Planning & Urban Development Department
Jeff Levine, Director

RE: 433 Fore Street – Canal Plaza Hotel
Level III Site Plan Review
Application ID Number: 2012-558

SUBJECT: Canal Plaza Hotel, Site Plan Review

EXISTING CONDITIONS SURVEY
 PORTION OF 1 CANAL PLAZA, PORTLAND, MAINE

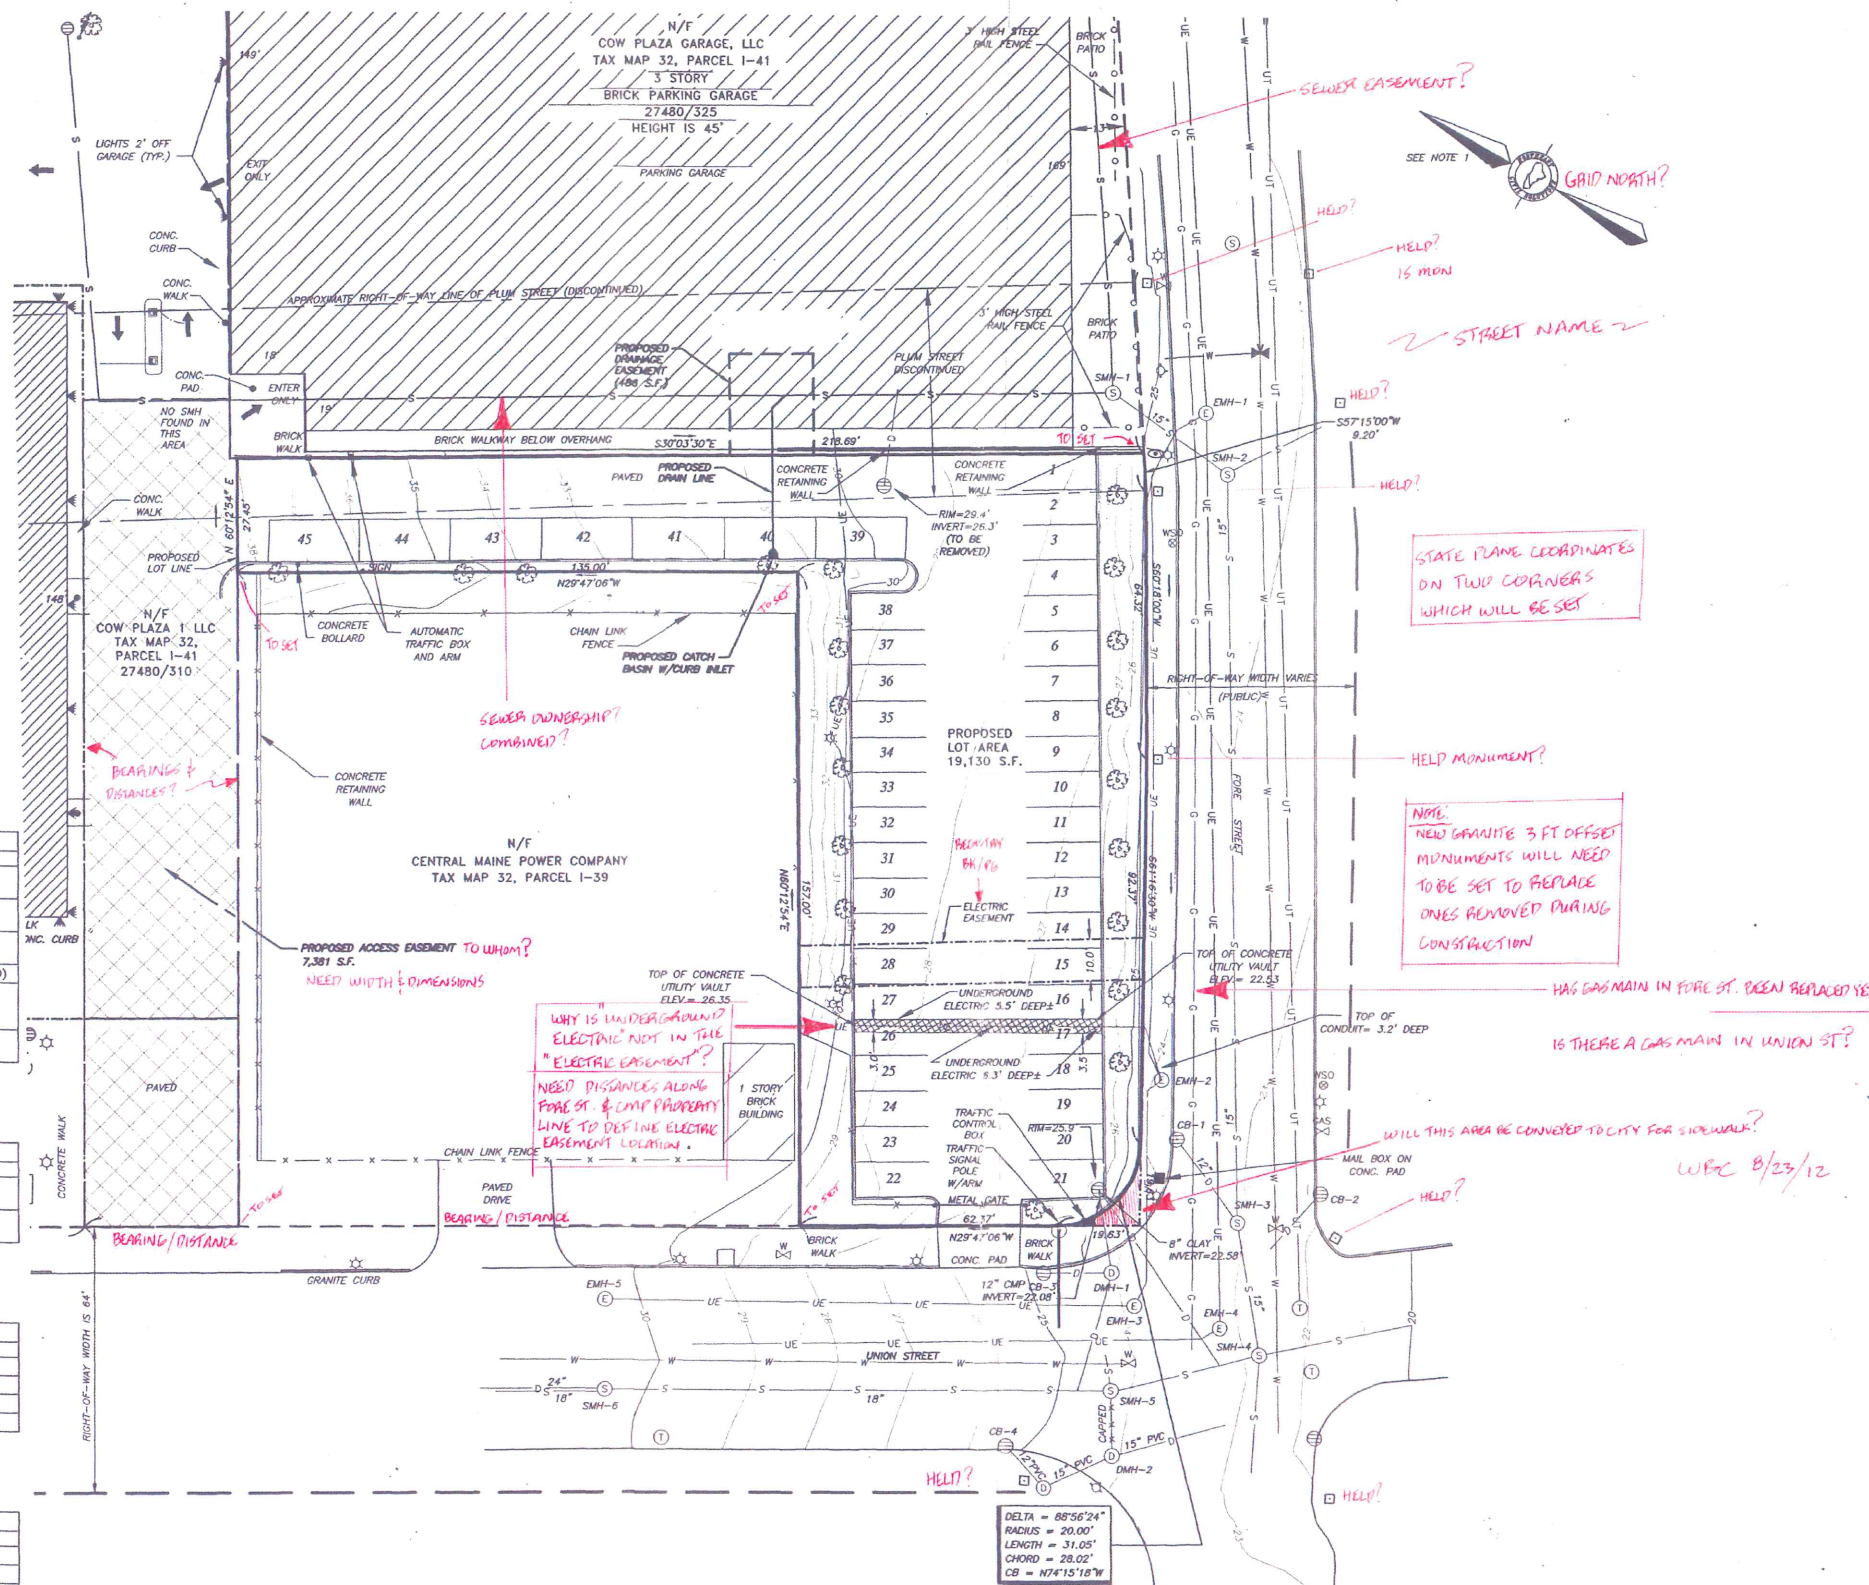
- UTILITIES SHOWN HEREON WERE TAKEN FROM THE PLANS REFERENCED IN NOTES 4.a., 4.b., 4.g., AND 4.h.
 - CONTOURS AND ELEVATIONS ARE NGVD 1929 DATUM.
 - WHAT CITY BENCHMARK WAS USED?
